Planning Committee

Application Address	Former Winter Gardens site, Keystone House and 20, 20a and 20b Exeter Road Bournemouth BH2 5AR
Proposal	Minor material amendment to remove conditions a and b of 7-2017-1273-AY, vary conditions c, 1 and 18 of 7-2017-1273-AY, and condition 2 of 7-2019-1273-BA, to include additional flats, reduction to basement structure and associated alterations to car park, changes to landscaping, redistribution of leisure space, reduction in size of the convenience store and office space, reduction in residential parking spaces and elevation changes. (Outline Planning Application for demolition of existing buildings & construction of a mixed use scheme; comprising residential apartments (use class C3) in buildings between 3 storeys & 15 storeys, leisure (use class D2), convenience retail (use class A1), restaurant/cafe (use class A3), mixed use restaurant/bar (use class A3/A4), offices (use class B1), associated servicing & loading areas, public car parking, private car parking, public open space, public realm enhancements & associated engineering works. Proposal affects a public right of way.)

Application Number	7-2020-1273-BB
Applicant	Bournemouth Develop

Cycle parking provision

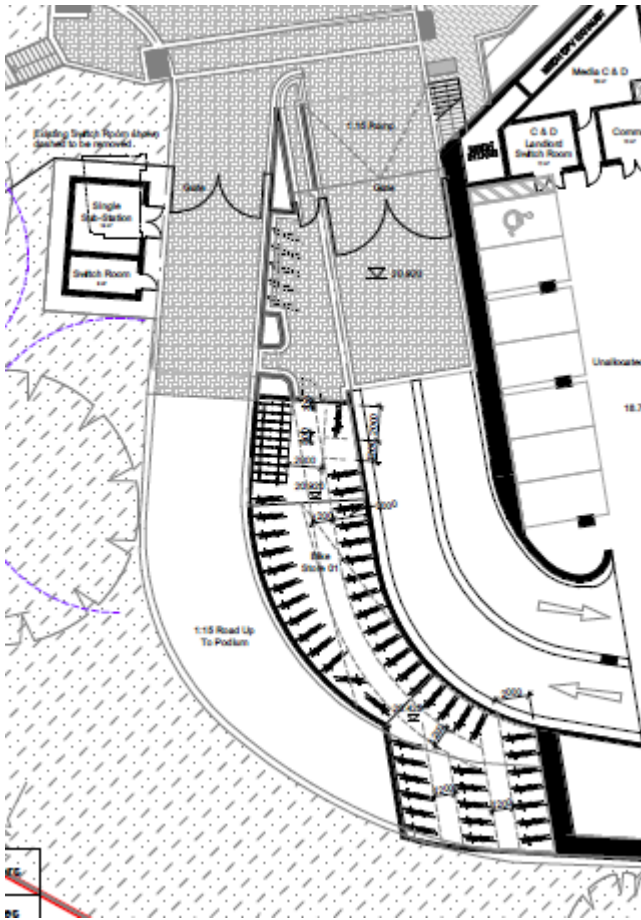
378 residential spaces are proposed plus 38 residential visitor spaces and 60 public visitor spaces. The level of provision is acceptable

Cranbourne Road southern footway/Boardwalk

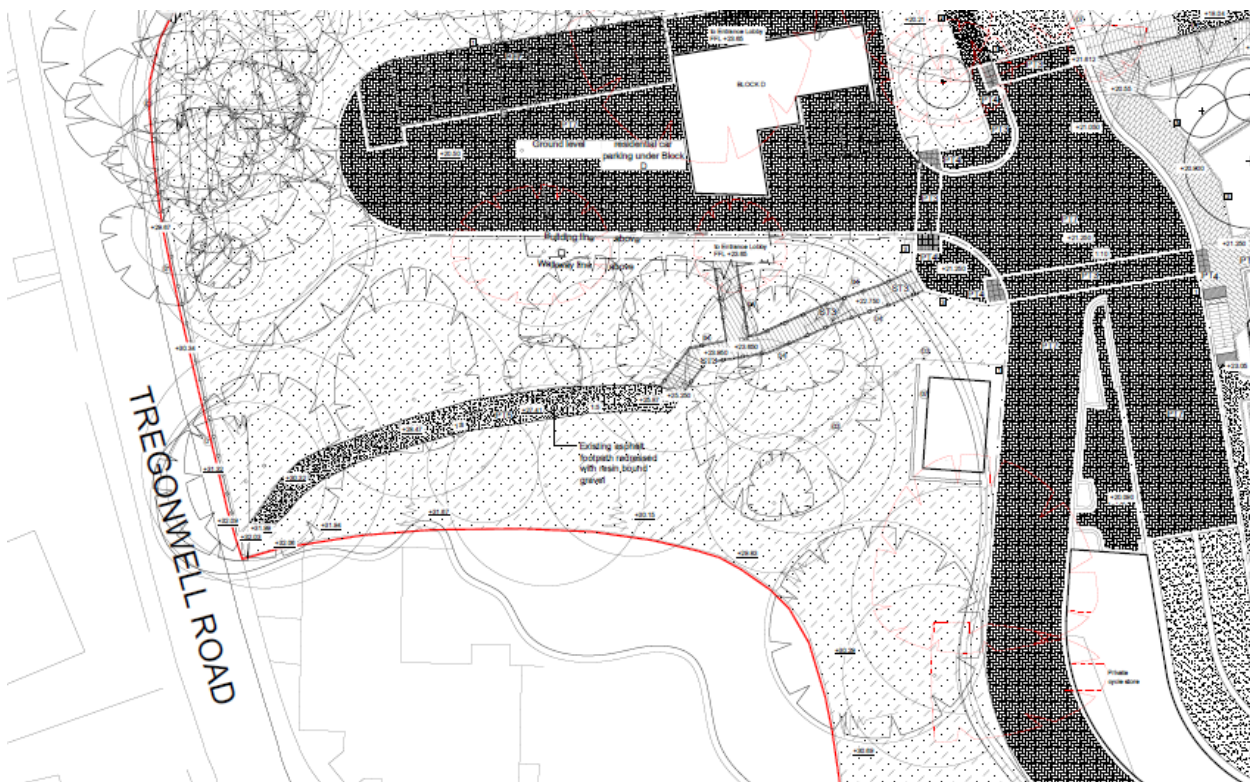
The applicant has advised that the MMA application does not propose any changes to the boardwalk from the approved scheme, so condition 27 should remain. This is acceptable.
